Docket #3602 - Non-compliance with Massachusetts Architectural Access Board Requirements

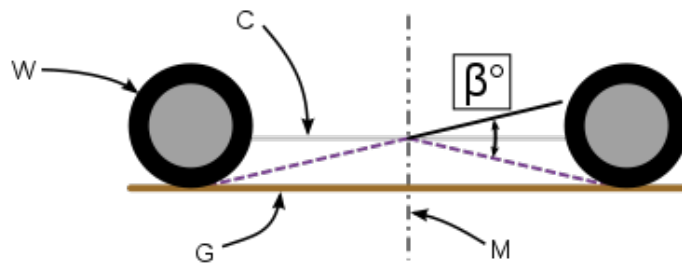
The most recent visualization continues to perpetuate the false notion that this entrance driveway is level. In fact, it is both steep and canted cross-wise. It has to accommodate a three foot drop from hotel entrance to sidewalk in only 24 feet.

Besides being a serious barrier to anyone with disabilities, the conditions of this driveway are unsafe for even able-bodied persons. Anyone exiting from the passenger side will find it exceedingly difficult to open their door; it will swing shut on them as they try to exit. On the driver's side, it will be all too easy to simply fall out of the vehicle. The raised island shown in the visualizations is not raised at all. It is actually a sunken pit, almost two feet below the driveway, with no protective railing to protect the unwary visitor.

Additionally, there is the "hump" in the middle of the driveway. The two opposite slopes create a "Breakover Angle" of 13.2° . Many common passenger vehicles do not have sufficient ground clearance to bridge this hump. An unloaded Toyota Camry will bottom out at 11.7° . A Prius at 11° , Hyundai Sonata and Ford Fusion at 10.8° , Chevy Malibu 9.4° . A Mercedes E class sedan can tolerate only 7.4° and will likely incur serious damage trying to bridge the hump.
https://en.wikipedia.org/wiki/Breakover_angle
